**Subject: Beaver Valley Power Station, Unit Nos. 1 and 2  
BV-1 Docket No. 50-334, License No. DPR-66  
BV-2 Docket No. 50-412, License No. NPF-73  
Supplement to License Amendment Request Nos. 296 and 169,  
Improved Standard Technical Specification Conversion**

**BVPS UNITS 1 & 2  
ITS CONVERSION LICENSE AMENDMENT  
REQUEST (LAR)  
Nos. 296 (UNIT 1) & 169 (UNIT 2)**

**REVISION 5 CHANGES  
Revision of Emergency Diesel Generator Run Time  
(ITS Surveillance Requirement 3.8.1.10)**

**ITS 3.8.1 &  
3.8.3**

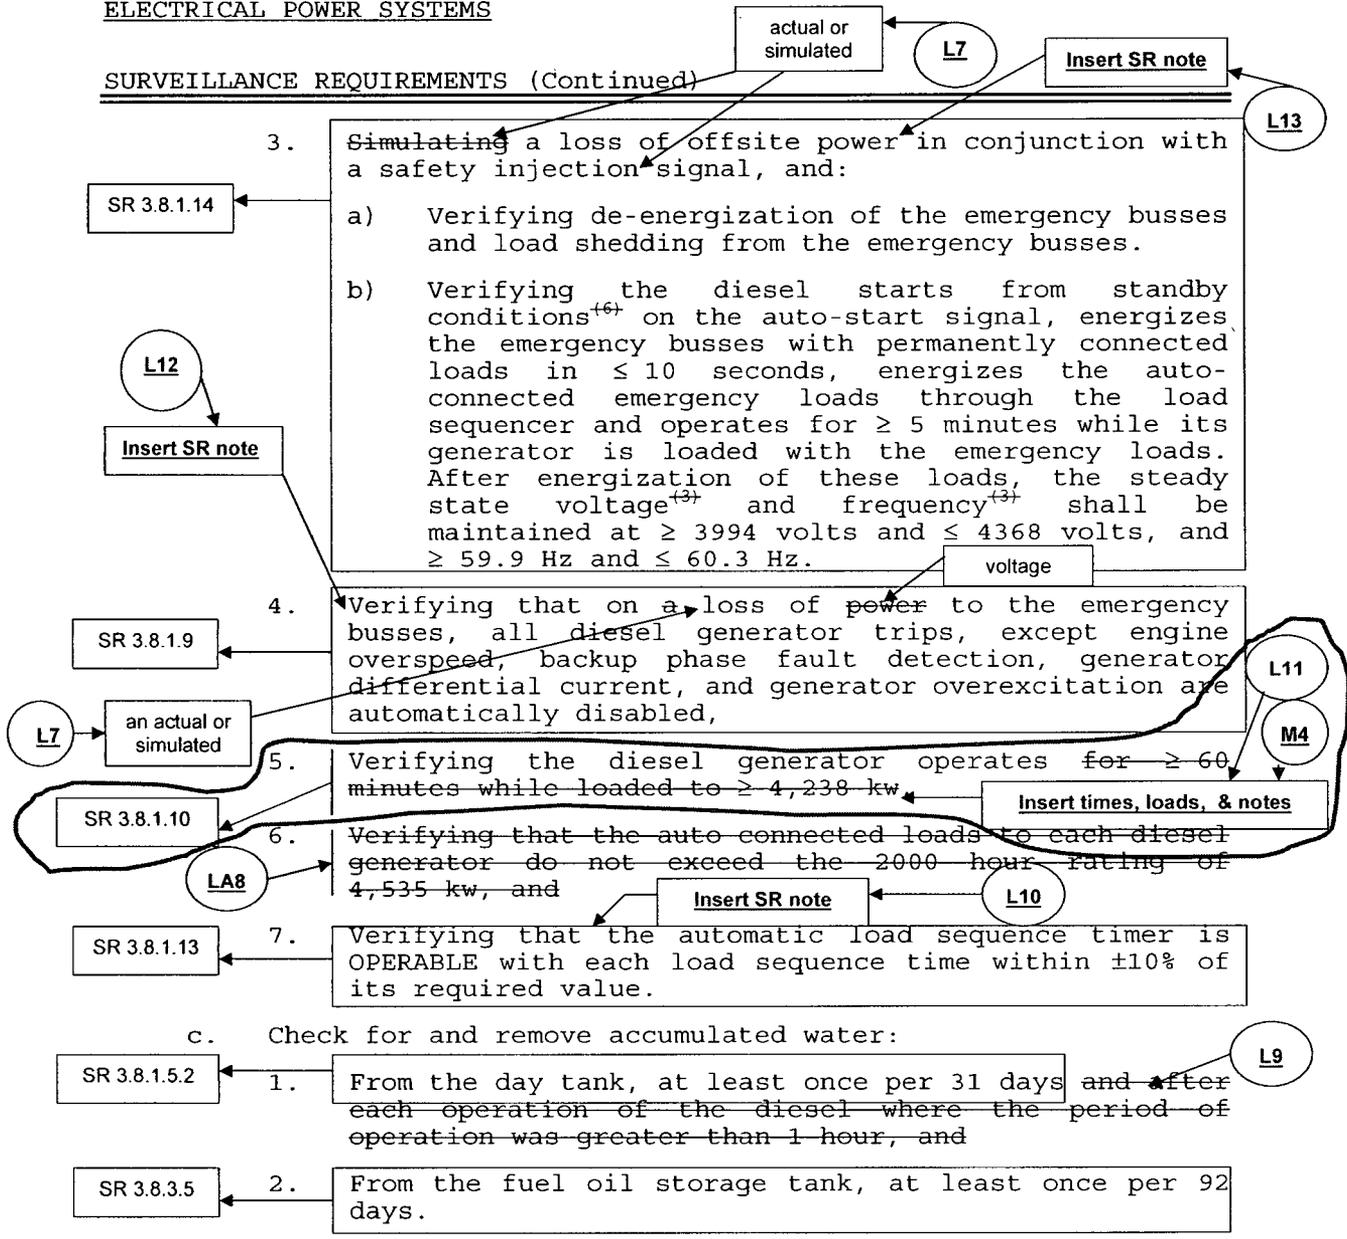
Included For Completeness Only. Revision 5 Changes Are Referenced From This Page. See Marked SR Below (ITS SR 3.8.10).

Time, load, and Note requirements for SR 3.8.1.10

for  $\geq 8$  hours:

a. For  $\geq 2$  hours loaded

$\geq 2750$  kW and  $\leq 2850$  kW (Unit 1)
